Wulfsberg Electronics <i>A Chelton Group Company</i>				
APPROVALS	DATE			TITLE: SERVICE INSTRUCTION WSI RT-30-2 REROUTING OF WIRE ON CHASSIS		
DRAWN J. Beaudette	09/16/04					
CHECKED C. Estes	09/16/04					
PRODUCT MANAGER S. Hovelsrud	09/16/04					
ENGINEER K. Harrar	09/16/04	SIZE A	CAGE CODE 1B7G3		DWG NO. 150-040989	REV A
ISSUED V. Wallace	09/16/04	SCALE: NONE			DO NOT SCALE DRAWING	
Typed signatures indicate approval. Handwritten signature approval of this document is on file at Wulfsberg Electronics, Prescott, Arizona.

SERVICE INSTRUCTION

INSTRUCTION NUMBER: WSI RT-30-2 150-040989 Revision A

Motorola p/n MHW591 (106-7080-000) is obsolete. This part needs to be substituted with replacement Motorola p/n MHW590 (106-741333-01) which requires rework. This rework applies to units built using p/n 148-0232-000 Rev. J or lower. For units built using p/n 148-0232-000 Rev. K, the wire between P7 Pin 7 and Q5 Pin 3 for the RT-30 R/T board is shorting to the chassis and needs to be routed on the back side of the board.

Figure 1A

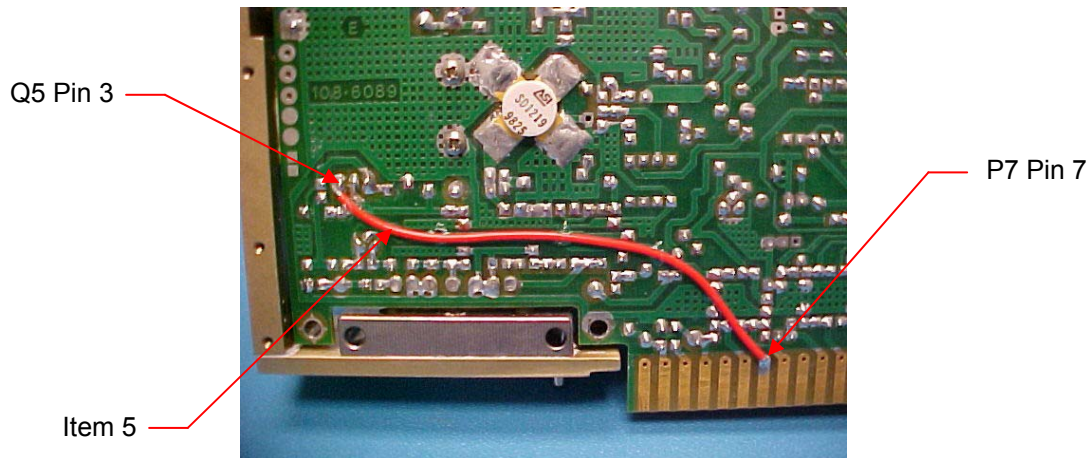
1. Run Item 5 from P7 Pin 7 to Q5 Pin 3. See Figure 1A.
2. Run Item 5 from P6 Pin 10 to P7 Pin 7. See Figure 2A.
3. Add Item 4 (100pF capacitor) to P7 between pins 5 and 7. See Figure 2A.
4. Change R51 to Item 1 (15K resistor). See Figure 3A.
5. Change R52 to Item 2 (22K resistor). See Figure 3A.
6. Change R108 to Item 3 (47K resistor). See Figure 3A.
7. Cut trace between R66 and Q5 just before the trace goes under L23. See Figure 3A.

Figure 1B

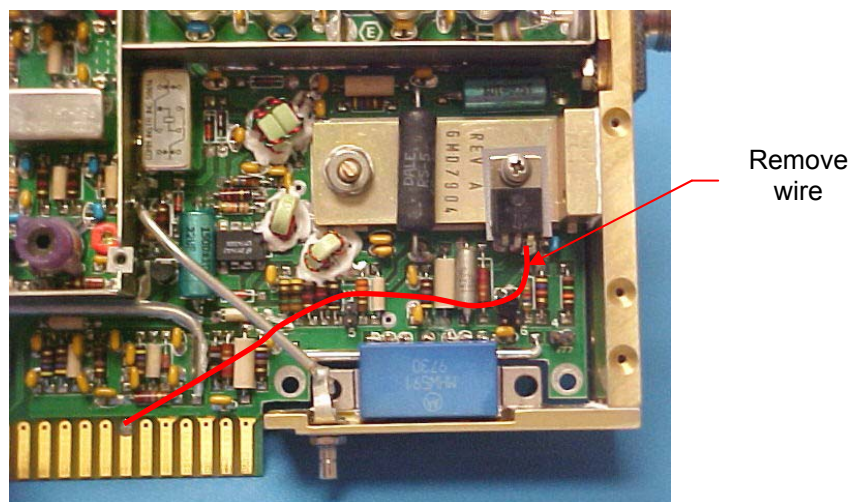
1. Remove wire from P7 Pin 7 and Q5 Pin 3 as shown in Figure 1B.
2. On opposite side of board, run Item 1 from P7 Pin 7 to Q5 Pin 3 as shown in Figure 2B.
